INSTRUCTIONS FOR INSTALLING THE 195022 MODIFICATION
KIT TO CONVERT FAA MODEL 28 ASR SETS WITH KEYBOARDS
LAK4 OR 25 TO CONFORM TO VSL245; KIT 195023 TO MAKE
FAA MODEL 28 ASR SETS WITH KEYBOARD LAK26 COMPATIBLE
WITH VSL245 SETS; AND KIT 195036 TO PROVIDE LINE RELAY
AND LINE SHUNT RELAY FOR AUXILIARY TYPING REPERFORATOR
(LPR) FOR FAA

FIGURE 1

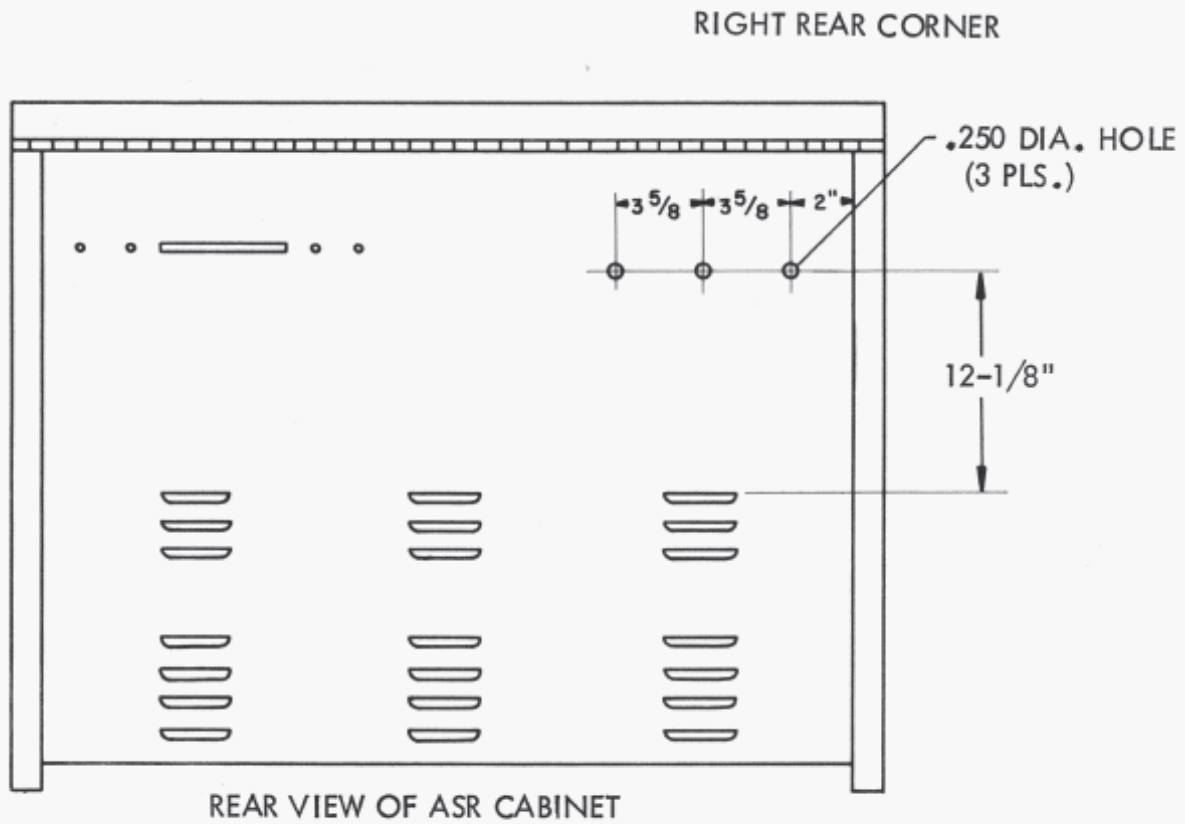
- (c) Install the 178599 Keyboard Cable Assembly and wire per 4748WD.
- (d) Remove and discard the 161237 Cable and Connector Assembly on LPR and replace with the 179628 Cable and Connector Assembly. Install per Figure 1 and 4748WD.

- (g) Mount the 179140 Auxiliary Line Shunt Relay Assembly using the two 179484 Screws and two 153017 Speed Nuts. Install per Figure 1, wire per 4748WD.

- (h) Mount the 179139 Line Relay Mounting Assembly using the two 179484 Screws and two 153017 Speed Nuts. Install per Figure 1, wire per 4748WD.
- (i) Relocate the transmitter unit line shunt relay as follows:

- 1. Remove line shunt relay from bottom cavity of cabinet. Retain mounting hardware.
 - 2. Reinstall the line shunt relay to the left rear inside wall of the cabinet as shown in Figure 1.

(h) Install the 179431 X-Connector Cable per Figure 1 and 4750WD.

FIGURE 3

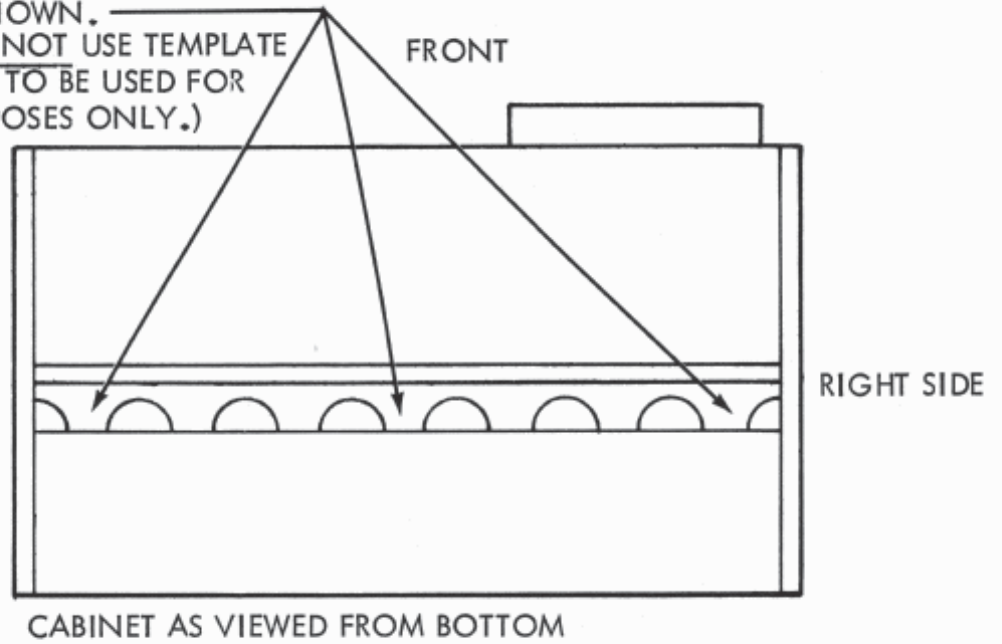
- 2. Remove and discard the existing 159735 Left Stationary Panel and associated mounting hardware.
 - 3. Drill the six 7/32 diameter holes in bottom side of cabinet shelf per Figure 3. The 195029 Template is provided for depth location as shown in Figure 4.

LOCATE AND DRILL 7/32 DIA.
HOLES WITH TEMPLATE IN APPROX.
POSITION AS SHOWN.
(CAUTION: DO NOT USE TEMPLATE
FOR DRILLING. TO BE USED FOR
LOCATING PURPOSES ONLY.)

FIGURE 4

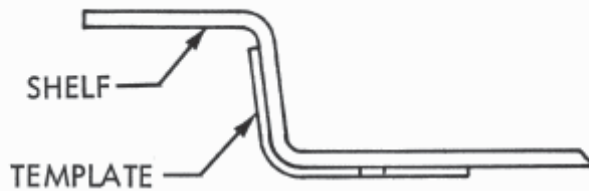
Do not attempt to drill through template, to be used for locating purposes only.

FIGURE 5

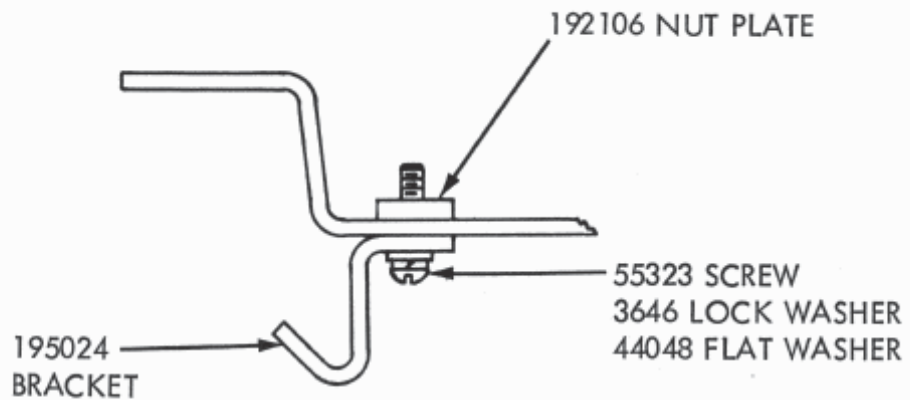
4. Install the three 195024 Panel Mounting Brackets using the six 55323 Screws, six 3646 Lockwashers, six 44048 Flat Washers, and the three 192106 Nut Plates, per Figure 5. The 154252 Door Panel may be installed on the unit at any time.

FIGURE 6

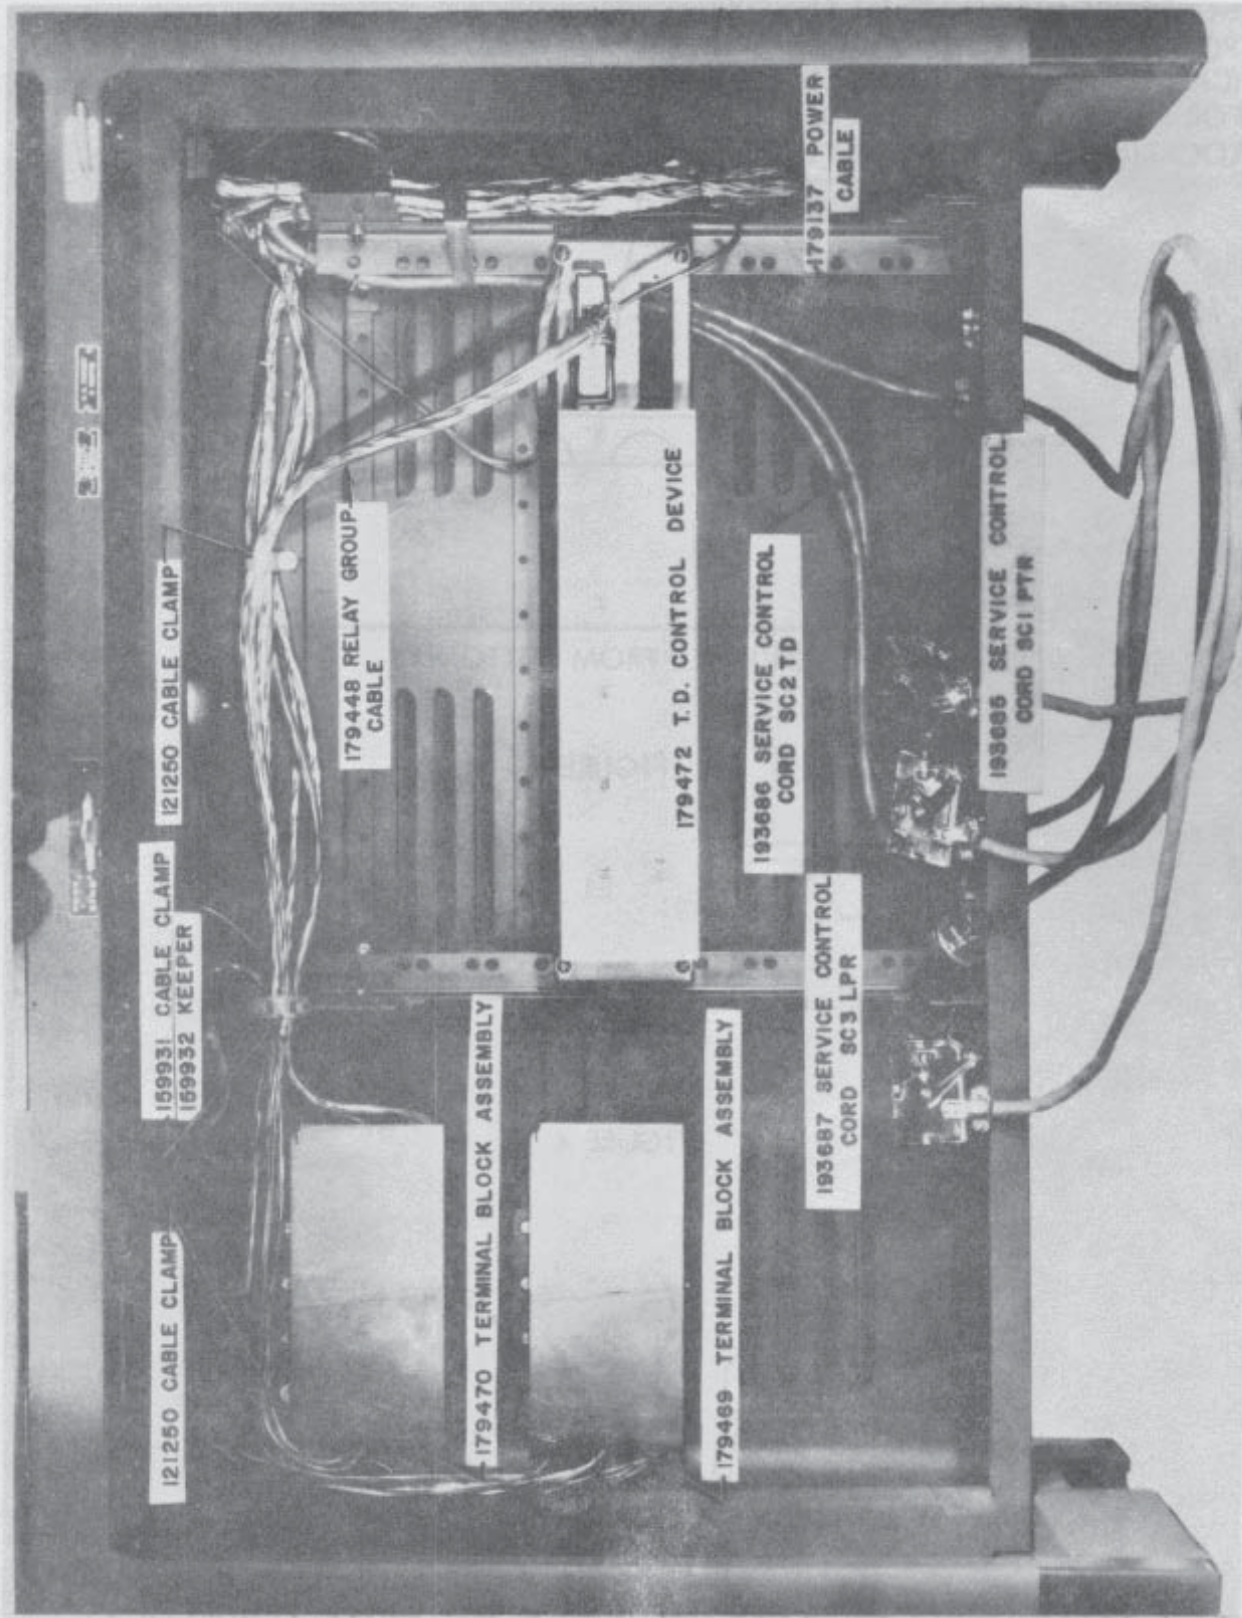
(d) Mount the two new terminal board assemblies as shown in Figure 6 using the six 179484 Screws and the six 153017 Speed Nuts.

(e) Install the 193685 Service Cord (PTR) per Figure 6 and 4750WD.

(f) Install the 193686 Service Cord (TD) per Figure 6 and 4750WD.

(g) Install the 193687 Service Cord (LPR) per Figure 6 and 4750WD.

(j) Remove and discard existing relay group cable (transmitter control) and replace with 179448 Cable Assembly, install per Figure 6 and 3464WD.

(k) Install the 159931 Cable Clamp and the 159932 Keeper, using one 55219 Screw, and one 115594 Speed Nut. Per Figure 6.

(l) Install the two 121250 Cable Clamps using the two 55219 Screws, two 35826 Flat Washers and two 115594 Nuts. Per Figure 6.

FIGURE 7

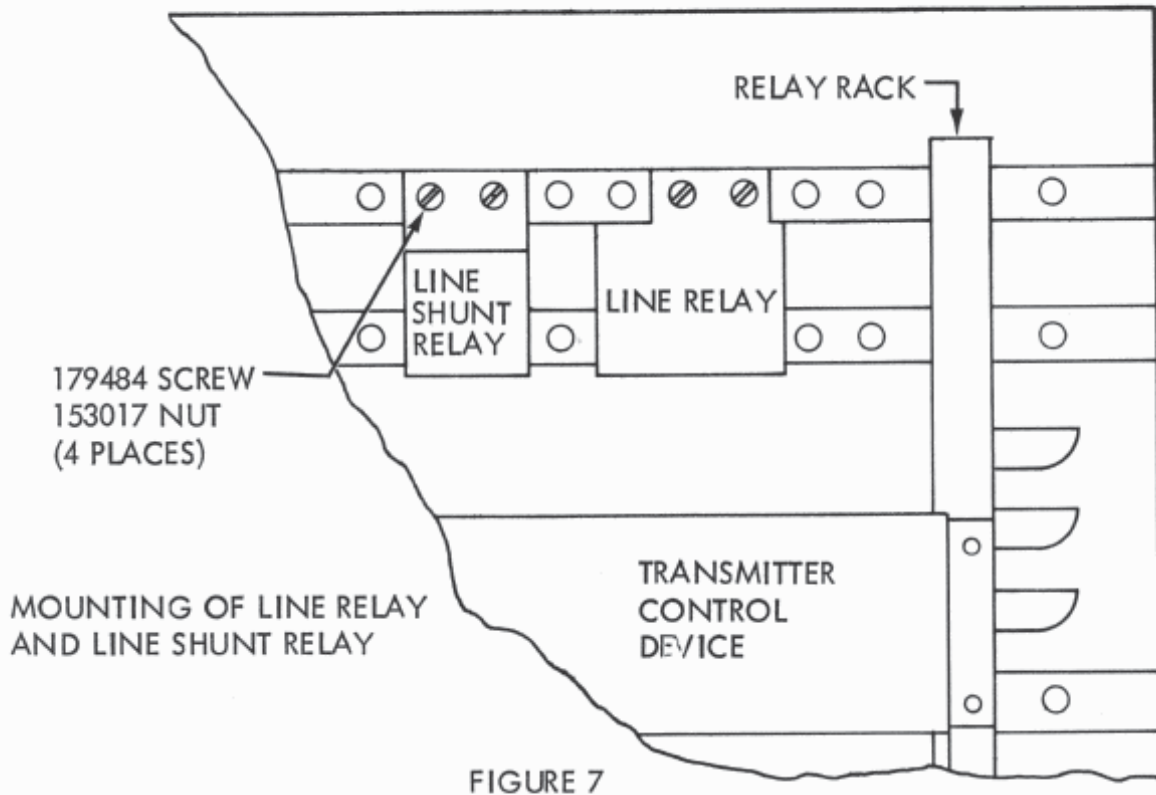
(1) Install the line shunt relay in the lower cavity of the LAAC Cabinet per Figure 7 using the four 179484 Screws, and four 153017 Speed Nuts.

FIGURE 8

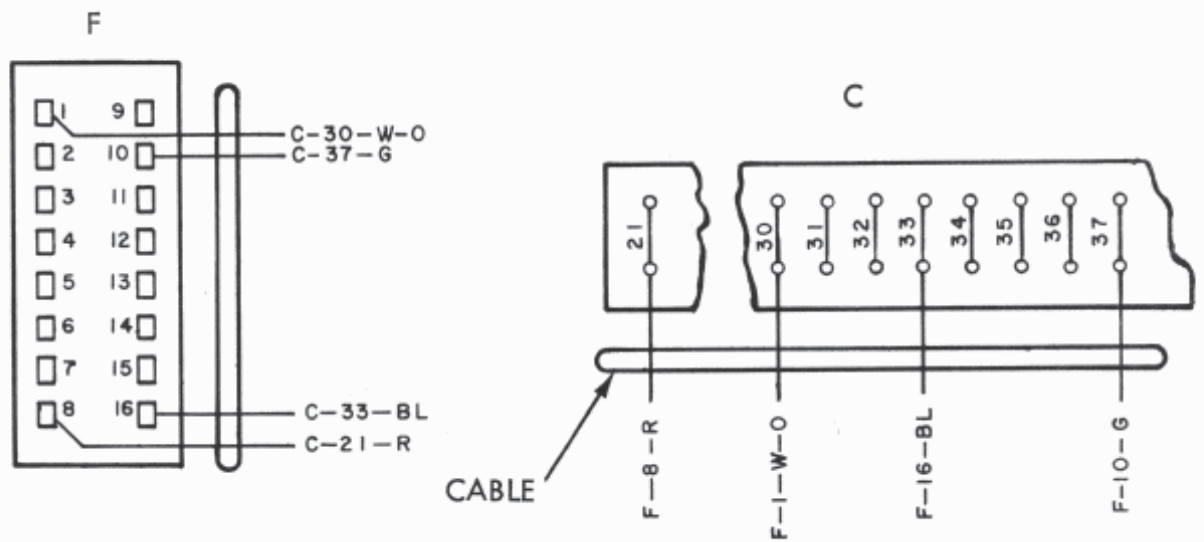
(4) Install the 195039 Cable per Figure 8.
